Downstream Analysis – Wrong Method completed by Applicant

*Downstream Analysis-
Wrong Method completed by Applicant
does not address the potential for
downstream flooding*

Project Name Proposed Hotel Facility

Project Name Gooding Avenue Development

Reach 11 Silver Creek from site Avg Flow Depth=2.39' Max Vel=4.23 fps Inflow=1,269.86 cfs 194.099 af
 n=0.035 L=7,022.0' S=0.0078 ' Capacity=6,919.98 cfs Outflow=967.37 cfs 194.099 af

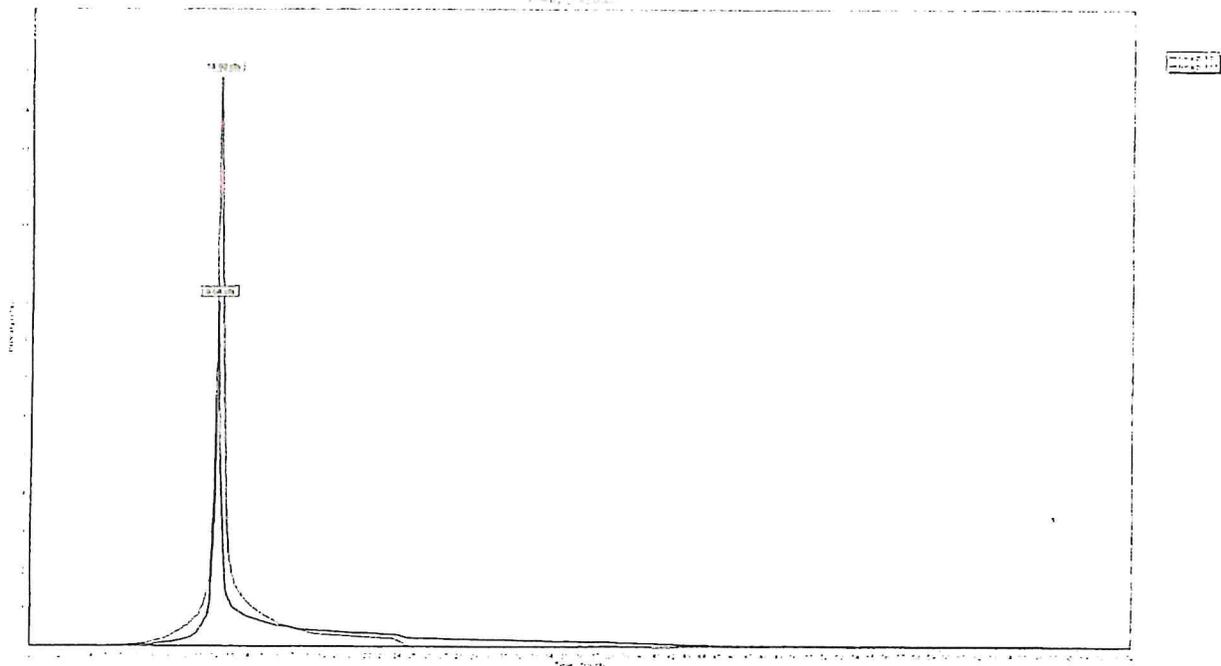
- **Comment on DiPrete HydroCADreach model results**

Conclusion A Downstream Analysis should be completed. It is my opinion, that after several RIDEM reviews of the Applicant’s submittals and numerous requests to conduct the analysis, using the appropriate HEC-RAS method, RIDEM accepted a useless and erroneous assessment. RIDEM accepted the Applicant excuse of “Not having the raw watershed data from the BETA study, we model the following parameters. It is curious why RIDEM ignored their own requirements and accepted such a useless assessment of the flooding issues.

Post-development passes pre-development hydrograph (both flows less than 0.5 cfs)

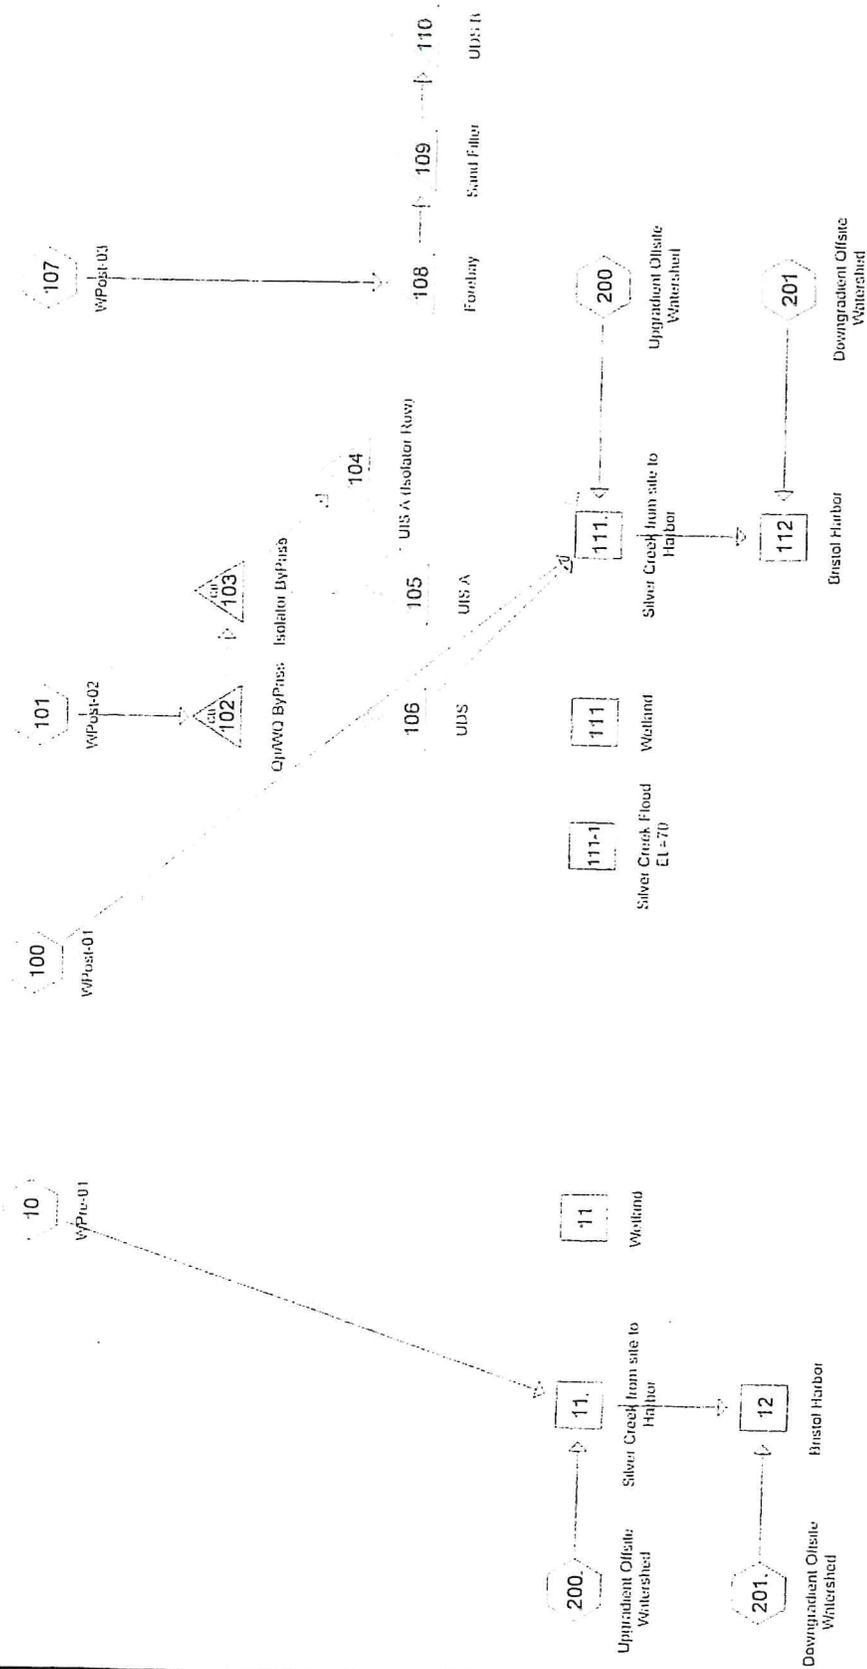
14. Please provide a comparison of the existing condition hydrograph and the proposed condition hydrograph. Please address whether there will be an increase in either the peak of any of the proposed condition hydrographs or whether there will be any change in the time of the peak of the proposed condition hydrograph. Please perform this task for the 1, 10, and 100-year 24-hour Type III storm events.

Comparison of the design points has been provided for each of these storms. The peak flows under proposed conditions will be at a lower magnitude for all storms, and occur approximately 0.1 hours earlier. As shown in these comparisons, the only occurrence of the proposed outflow surpassing existing outflow occurs at approximately hour 16.5, when both the existing and proposed flows are under 0.5 cfs. As marked on the hydrograph table provided in response to #13, this crossing of hydrographs will occur when the Silver Creek design point is discharging at 82.3 cfs, a fraction of the peak of 1,266 cfs occurring at Hour 12.57. ✓
